Access Compliance Report

Public Rights-of-Way

(Curb Ramps)

Intersection ID: 18196	Main Street: E_WOODLAWN_RD	Cross Street: WATERBURY_DR	Location: NW
ADA ID: EF8190D0E739	Ramp Type: ParaDiag	Initial Pass/Fail: Fail	Overall Compliance: No
			Severity Score: 26.25

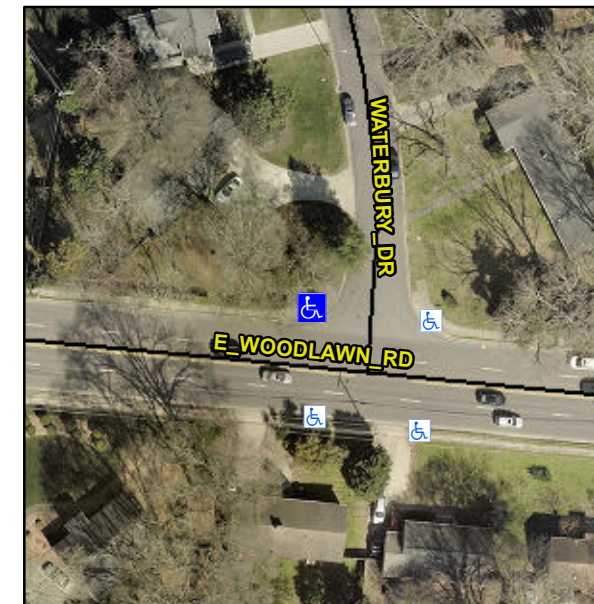
ASP LIP 2.0, RT RP < 5%

R304.3.2, R304.5.3

Compliance	Description	Data	Compliance	Description	Data
N/A	Ramp Length LT (in)	64.0	N/A	Ramp Length RT (in)	46.0
Yes	Ramp Width LT (in)	86.0	Yes	Ramp Width RT (in)	92.0
No	Ramp Slope LT (%)	16.1	Yes	Ramp Slope RT (%)	3.0
No	Ramp XSlope LT (%)	2.4	No	Ramp XSlope RT (%)	3.0
N/A	Landing Length (in)	N/A	N/A	DWS Provided?	N/A
N/A	Landing Width (in)	N/A	N/A	DWS Contrast?	N/A
N/A	Landing Slope (%)	N/A	N/A	DWS Length (in)	N/A
N/A	Landing X Slope (%)	N/A	N/A	DWS Full Width?	N/A
N/A	Landing Curb? (Y/N)	N/A	N/A	DWS Offset (in)	N/A
N/A	Shared Landing?	N/A			
N/A	Gutter Ponding?	N/A	N/A	Gutter Slope (%)	N/A
N/A	Gutter Lip Ht (in)	N/A	N/A	Gutter X Slope (%)	N/A
N/A	Painted X Walk1?	No	N/A	Painted X Walk2?	No
	X Walk 1 Direction	To S		X Walk 2 Direction	To E
N/A	X Walk 1 Width (in)	N/A	N/A	X Walk 2 Width (in)	N/A
	X Walk 1 Slope (%)	2.5		X Walk 2 Slope (%)	2.3
	X Walk 1 X Slope (%)	4.1		X Walk 2 X Slope (%)	5.3
N/A	Ramp inside XWalk1?	N/A	N/A	Ramp inside XWalk2?	N/A

Remove & Replace Curb Ramp With Two New Directional Ramps or Equivalent.
